SUBJECT : ImageQuest Co., Ltd.
FCC ID: PJIL19A0D061
Class II permissive change
Orig. Grant Date: June 17, 2003

Transmitted herewith, on behalf of ImageQuest Co., Ltd. is an application for a Class II Permissive Change Certification of the following 17-inch LCD Monitor:

FCC ID : PJIL19A0D061
Model/Type : L19T/L19A0D061

• Solution for EMI

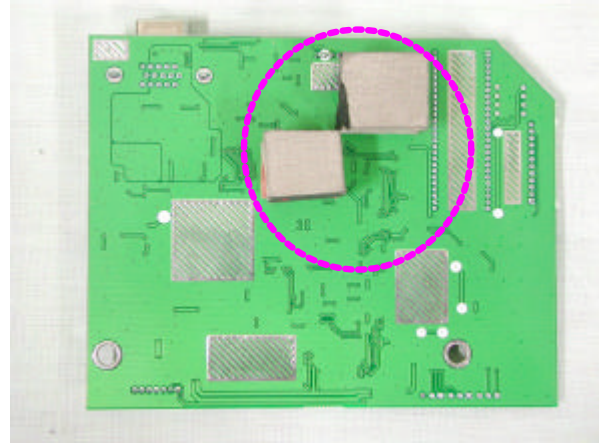
1. Attach a gasket on the Main Board and Main Frame to contact a LCD panel

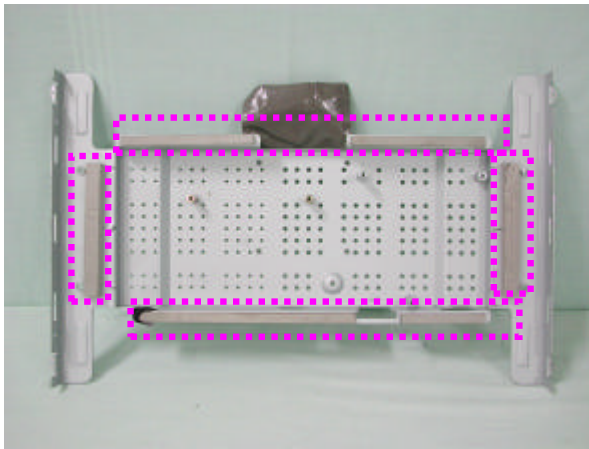
2. Attach a gasket on the Audio PCB to contact a stand

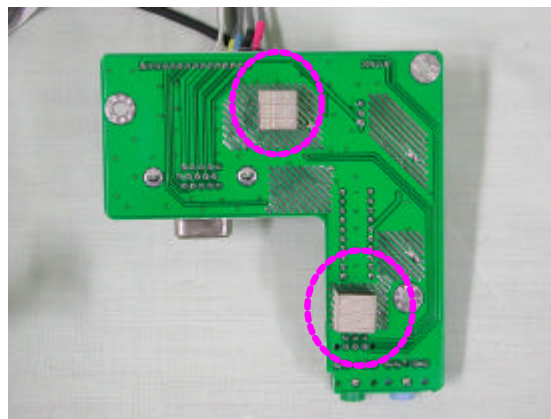
3. Attach a gasket and aluminum foil between Main Frame and LCD panel

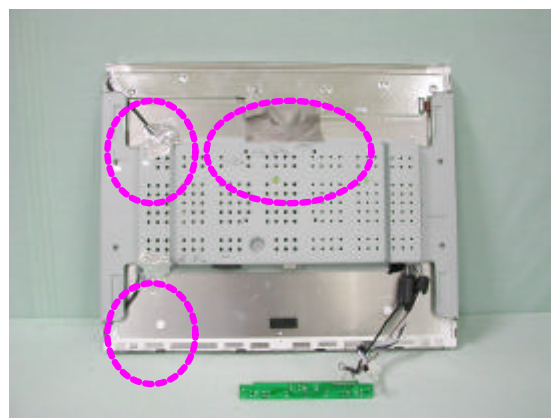
4. Apply a ferrite Core to the Audio Cable, Multi cable and OSD board signal cable
